SERVICE BULLETIN

SB1243

ADDRESSEES	: ABC Customer Care and Parts Source Owners and operators of coaches listed under 'Application'
VEHICLE MODEL	: TD925US
SYSTEM/SUBSYSTEM	: Climate control – Auxiliary heater
BULLETIN TYPE	: Product Improvement
DATE	: May 9, 2011
SUBJECT	: Auxiliary heater – Extended exhaust pipe
TERMS & CONDITIONS	: Note that no reimbursement will be awarded for carrying out this Product Improvement.

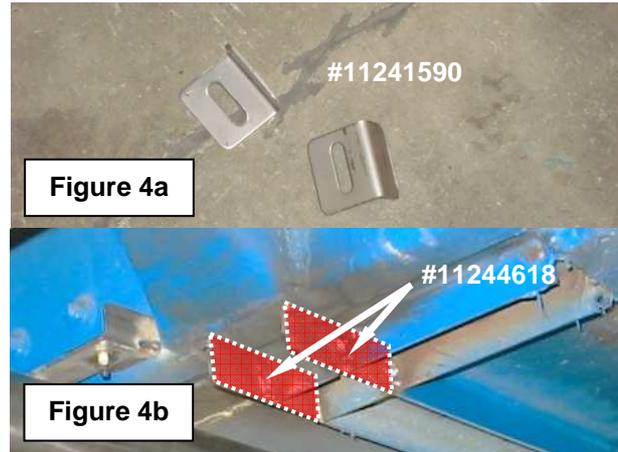
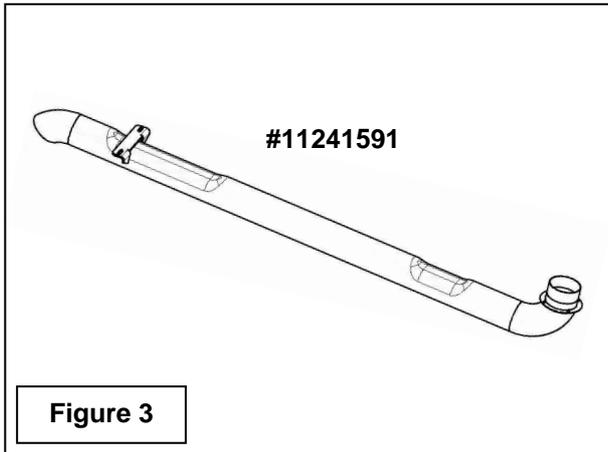
1. As from double-deck coach #42402, the auxiliary heater diffuser exhaust (Figure 1) has been replaced by an elbow and pipe that direct the heater exhaust gases to the rear of the vehicle (Figure 2).

2. The new installation prevents heater exhaust fumes from entering the luggage compartment when the vehicle is stationary and thus eliminates a source of discomfort for drivers and baggage handlers.
3. Owners and operators who wish to retrofit this product improvement to their coaches may purchase the parts and install them as described in this Bulletin.

Figure 12a

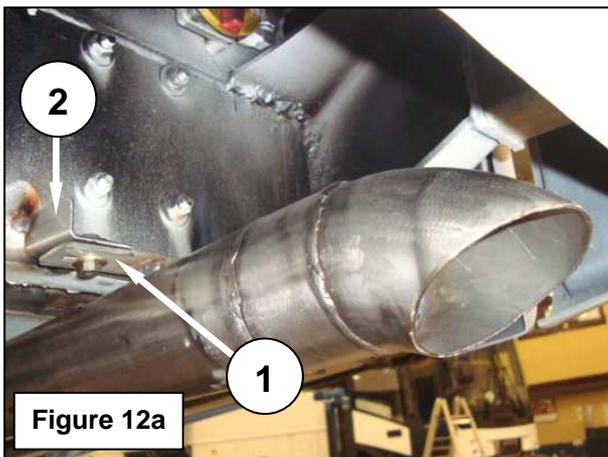
Attach support brackets #11241590 for a loose fit to the support bracket that has been welded to the exhaust pipe (1, Figure 12a).

Tack weld then fully weld support brackets #11241590 to the battery/auxiliary heater compartment wall as shown in 2, Figure 12a and Figure 12b.
Remove the exhaust pipe.

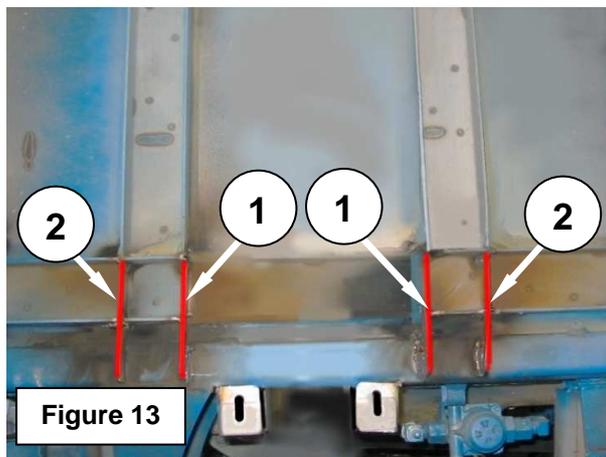
- 5) Referring to 2, Figure 13 cut slots in the U-channel frame to accept reinforcing brackets #11244618.
Tack weld then fully weld the reinforcing brackets in place.
Close the U-channel open ends by welding on the remaining reinforcing brackets #11244618 (1, Figure 13).
This to provide a box section.
Weld all reinforcing brackets #11244618 to the compartment floor.

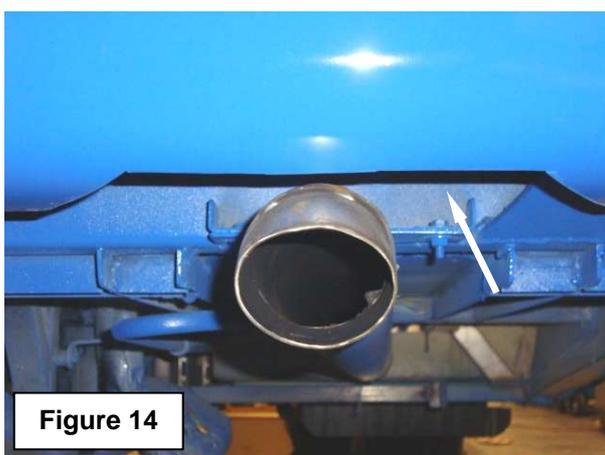
***NOTE:** Before installing new exhaust pipe #11241591 on units equipped with a flat rear bumper, it is necessary to first provide a recess in the bumper for clearance (Figure 14).*

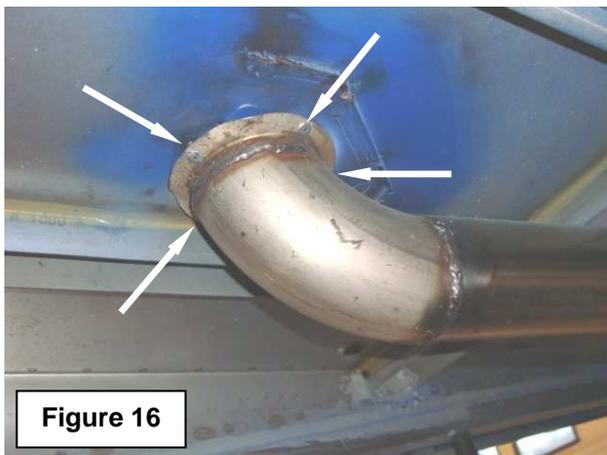
- 1) Attach exhaust pipe #11241591 for a loose fit to support brackets #11241590 using the fasteners from the material's list (Figure 15).

- 2) Insert the exhaust pipe elbow into the battery/auxiliary heater compartment floor. When fully seated, secure the pipe with blind rivets #10511407 (Figure 16) to the floor. Tighten the support bracket fasteners to a torque of 80 in.lbf.
